SERVICE BULLETIN

SERVICE BULLETIN NO: 30-011 REF NO: 216

ICE AND RAIN PROTECTION - AIRFOIL DEICE SYSTEM INSTALLATION OF AN OVERBOARD VENT FOR THE PRESSURE REGULATOR

Overboard Vent - Installation Figure 1 (Sheet 2 of 2)

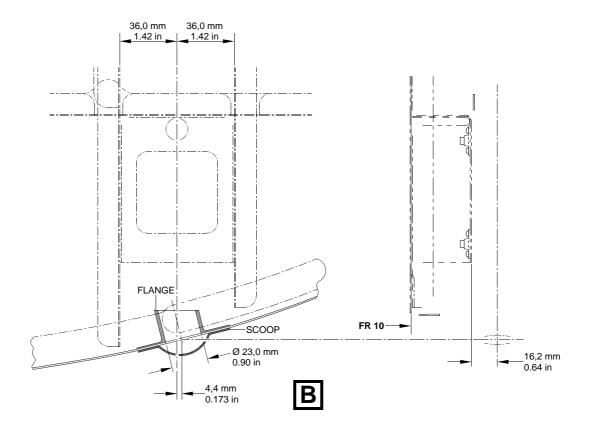
- (13) Remove the gripper pins, and the scoop (3).
- (14) Carefully lift the pressure regulator assembly until you can remove the flange (1).
- (15) Find the center of the vent hole position (Ref. Fig. 1, Sheet 2):
 - (a) Make a line on the fuselage skin (2) between the opposite rivet holes X-X.
 - (b) Make a line on the fuselage skin (2) between the opposite rivet holes Y-Y.
 - (c) The point where the lines cross is the center of the vent hole position.
- (16) Make a 23 mm (0.90 in.) hole through the aircraft skin at the marked vent hole position.
- (17) Deburr the holes as necessary.

Overboard Vent - Installation Figure 1 (Sheet 1 of 2)

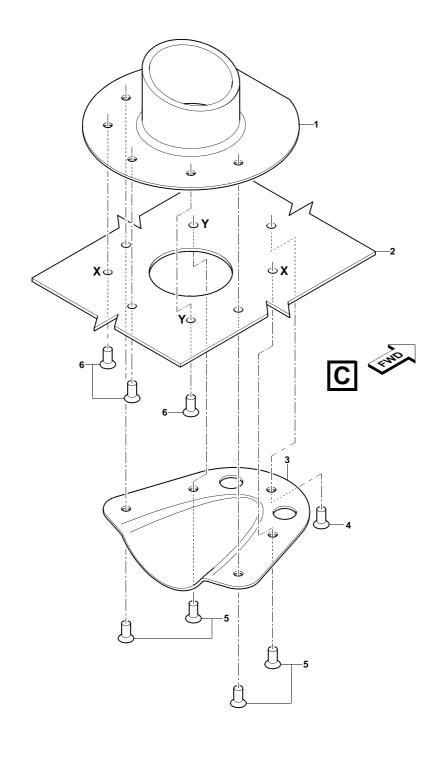
If incorrectly adjusted, or defective, the Deice Pressure Regulator can vent hot air into the forward compartment. This can cause heat damage to the cables and components in the compartment.

Install a flange and scoop in the aircraft skin to vent the hot air from the Deice Pressure Regulator overboard.

This Service Bulletin gives the data and instructions necessary to install a flange and scoop in the aircraft skin to align with the vent stub-pipe of the Deice Pressure Regulator.

- (1) Loosen, but do not remove, the four bolts that attach the pressure regulator assembly to the structure (Ref. AMM 12-A-30-10-01-001A-920A-A).
- (2) Carefully lift the pressure regulator assembly until you can put the flange (1) (P/N 553.14.12.647) in the installed position.

- (3) Tighten the four bolts that attach the pressure regulator assembly to the structure.
- (4) Move the flange (1) to get the vent stub-pipe of the pressure regulator in the center of the vent tube on the flange (1). The five rivet holes in the flange (1) must face aft and the straight edge must face forwards.

- (9) Carefully lift the pressure regulator assembly until you can put the flange (1) in the installed position.
- (10) Put the scoop (3) (P/N 553.30.09.199) in position on the outside of the skin (2). The open end of the scoop (3) must face aft. Align the two aft holes in the scoop (3) with the two forward holes drilled in Step (8).

- (11) Install gripper pins to hold the flange (1) and the scoop (3) in position on the skin (2).
- (12) Drill 2,5 mm (0.1 in.) holes through the holes in the scoop (3).

NOTE: The holes for the four rivets (5) go through the skin (2) and the flange (1). The hole for the rivet (4) goes through the skin (2) only.

- (20) Install the scoop (3):
 - (a) Apply a layer of sealant (Material No. P08-018) to the mating surface of the scoop (3).
 - (b) Install the four rivets (5) (P/N 939.27.81.353) through the scoop (3), skin (2) and flange (1).

- (c) Install the rivet (4) (P/N 939.27.81.353) through the scoop (3) and skin (2).
- (21) Use absorbent paper (Material No. P02-031) and solvent (Material No. P01-008) to remove unwanted sealant.
